**No. 94-14**

## A. WIRING MODIFICATION

MCM / MIE D3.0L Serial Number 0D725223 - 0D725288  
MCM / MIE D3.6L Serial Number 0D850333 - 0D850454  
MCM / MIE D4.2L Serial Number 0D555036 - 0D319255

### D3.0L/150, D3.6L/180 and D4.2/220

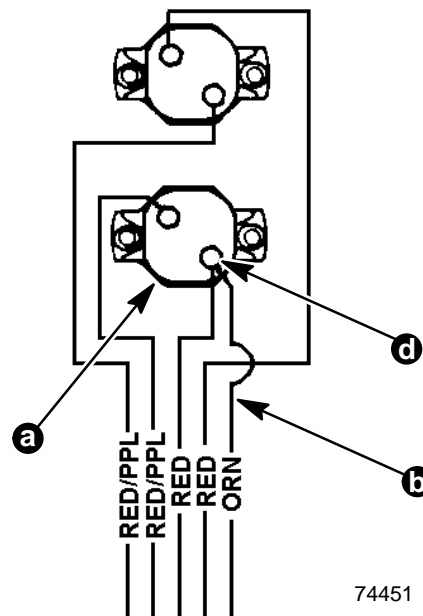
The above model engines in the serial groups indicated are equipped with Mando alternators. These models have the alternator output lead wired through the 60 amp circuit breaker. The output of some of the alternators may cause the circuit breaker to trip causing premature failure of the voltage regulator or other electrical components.

Go to 60 amp circuit breaker with the ORANGE alternator output lead attached to it. Move the ORANGE wire from the connection with the RED/PURPLE wire, to the connection with the RED wire. See diagram below.

**Existing Connection**

**Reworked Connection**

- a - 60 Amp Circuit Breaker in Electrical Box
- b - ORANGE Wire From Alternator
- c - Connection Terminal For ORANGE Wire - Existing
- d - Connection Terminal For ORANGE Wire After Modification
